UNITED STATES PATENT AND TRADEMARK OFFICE

APPLICATION NO.	FILING DATE	FIRST NAMED INVENTOR	ATTORNEY DOCKET NO.	CONFIRMATION NO.
10/694,021	10/28/2003	Henry Rosenthal	116364	3701

Office Action Summary

ATTACHMENT

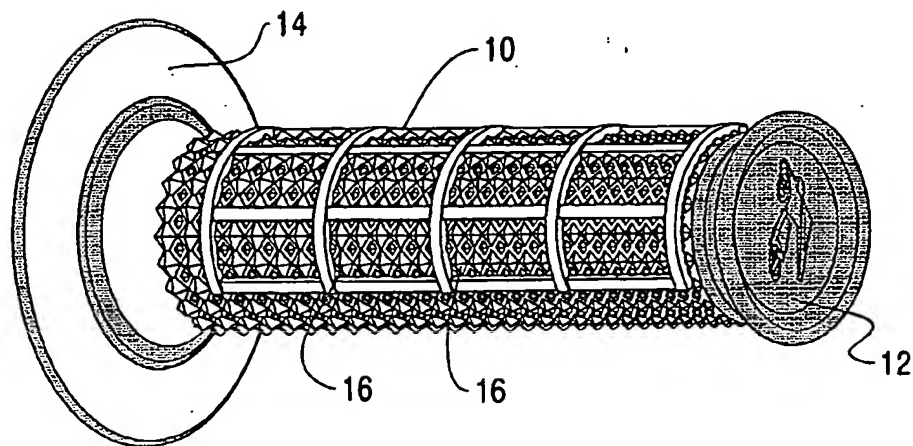
3. The drawings were received on November 3, 2004. These drawings are unacceptable by the Examiner because the corrected Fig. 1 and new Figs. 5-8 introduce new matter for the reasons, among other things, listed below:

(a) the new referential numeral 11 that indicates the inner layer of the body 10 as now shown in corrected Fig. 1 introduces new matter. See Attachment. Applicant's original disclosure does not disclose that the inner layer is extended to and contacted with the flange 14. In other words, the concept that the inner layer is extended to and contacted with the flange 14 is not conveyed in the original disclosure, *i.e.*, new matter. *In re Anderson*, 176 USPQ 331 (CCPA 1973);

(b) Applicant's original disclosure does not disclose that the inner layer, the flange 14, and the end wall 12 are formed as one piece as now shown in corrected Fig. 1. In fact, the description "[a] firmer less flexible grade is used to form a base or inner layer of the body 10,

as well as the end wall 12 and the flange 14” on page 4 of the original specification implies that the inner layer, the end wall 12, and the flange 14 are formed as separate pieces and connected together. In other words, the concept that the inner layer, the flange 14, and the end wall 12 are formed as one piece is not conveyed in the original disclosure, *i.e.*, new matter. *In re Anderson*, 176 USPQ 331 (CCPA 1973);

6. The amendment filed November 3, 2004 is objected to under 35 U.S.C. 132 because it introduces new matter into the disclosure. 35 U.S.C. 132 states that no amendment shall introduce new matter into the disclosure of the invention. The added material which is not supported by the original disclosure is as follows: the description of new Figs. 5-8 and the new referential numerals, such as, "11" to indicate the inner layer in corrected Fig. 1.

The Examiner respectfully submits that the original disclosure does not describe, among other things, that the inner layer is extended to and contacted with the flange 14. In other words, the concept that the inner layer is extended to and contacted with the flange 14 is not conveyed in the original disclosure, *i.e.*, new matter. *In re Anderson, supra*. See other new matter set forth in the disapproval for drawing correction in paragraph 3 above. Applicant is required to cancel the new matter in the reply to this Office Action.

FIG. 2

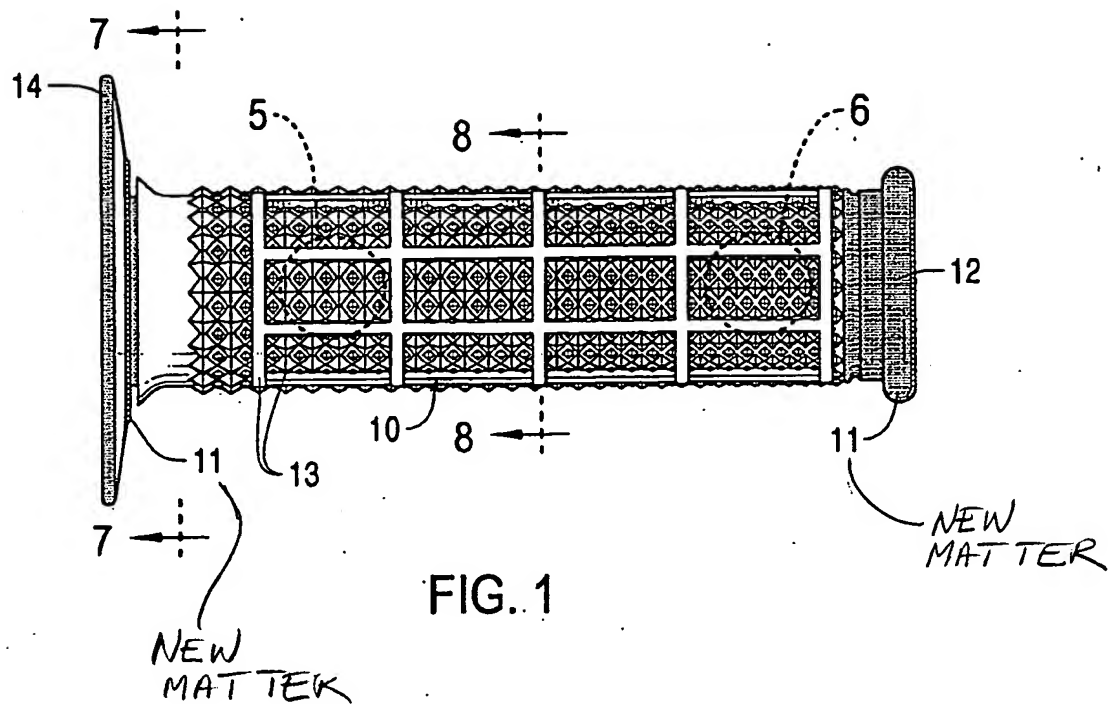
Regarding claim 3, Oury's second end is closed by an end wall as shown in Fig. 2.

FIG. 5

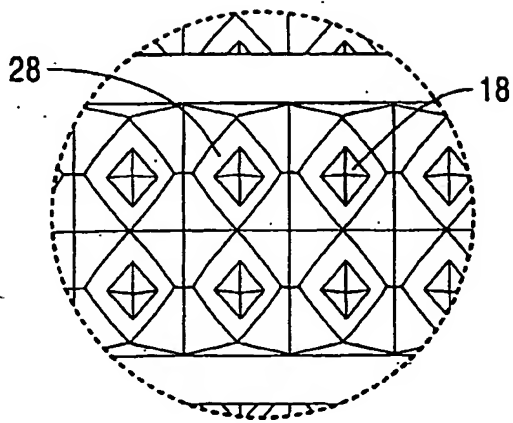
Applicant states “[s]upport for new Figs. 5 and 6 is provided in original Figs. 1-4, page 2, lines 15-18; page 2, lines 1-2; and page 4, lines 14-19. Support for new Figs. 7 and 8 is provided in original Figs. 1-4; page 3, lines 4-9; page 4, lines 7-12 and original claims 4-19. Thus, Figs. 5-8 do not contain new matter.”

Contrary to Applicant's remarks, the quoted portion in the original disclosure does not provide support, e.g., the thickness of the inner layer relative to the thickness of the outer layer as now shown in new Figs. 7 and 8. Therefore, new Figs. 5-8 contain new matter as explained in paragraph 3 above.

FIG. 7

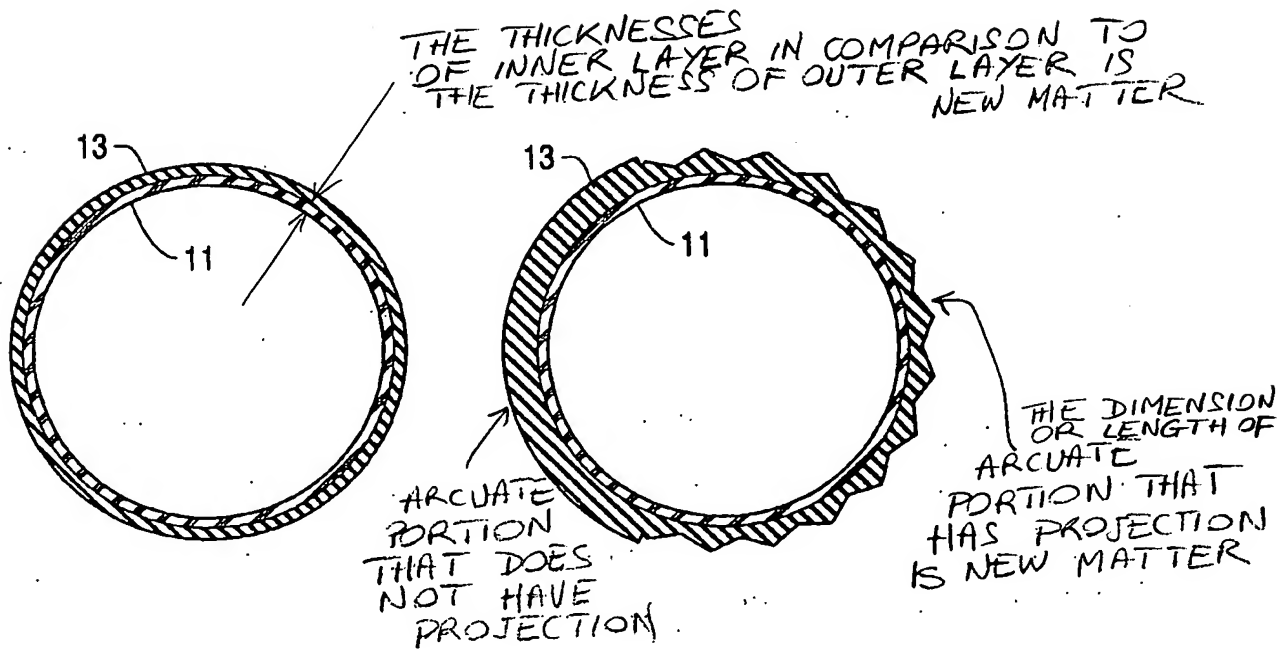
(c) the thickness of the inner layer (Att.) in comparison to the thickness of the outer layer as now shown in new Figs. 7 and 8 introduces new matter. The original disclosure does not describe the thickness of the inner layer in comparison to the thickness of the outer layer. Therefore, the original disclosure implies that the thickness of the inner layer may be equal, greater, or less than the thickness of the outer layer. The specific showing of the thickness of the inner layer relative to the thickness of the outer layer within a full spectrum of possible thicknesses is considered under the present disclosure to be new matter. *Cf.*, *In re Smith*, 173 USPQ 679 (CCPA 1972) and *Ex parte George*, 230 USPQ 575, 578 (BPAI 1986); and

(d) the arcuate portion of the outer surface of the outer layer that has projections as now shown in new Fig. 8 introduces new matter. The original disclosure does not describe that the arcuate portion that has projections is substantially greater than the other arcuate portion that does not have projection as now shown in Fig. 8. The original disclosure implies that the peripheral length or dimension of the arcuate portion that has projections may be equal, greater, or less than the peripheral length or dimension of the arcuate portion that does not have projection. The specific showing of the peripheral length or dimension of the arcuate portion that has projections relative to the peripheral length or dimension of the arcuate portion that does

Applicant contends that the amended drawings including new Figs. 7 and 8 show the inner and outer layers. However, the corrected drawings introduce new matter as explained above. *In re Smith* and *Ex parte George, supra*. To the extent that Applicants have complied with the Examiner's objection to the original drawings by corrected Fig. 1 and adding new Figs. 5-8 by submission of the amendment, the Examiner respectfully submits that the claimed feature in claims 4-9 required under 37 CFR 1.83 should have been shown *on the filing date*. The Applicant is respectfully advised that Section 608.01(h) of MPEP states:
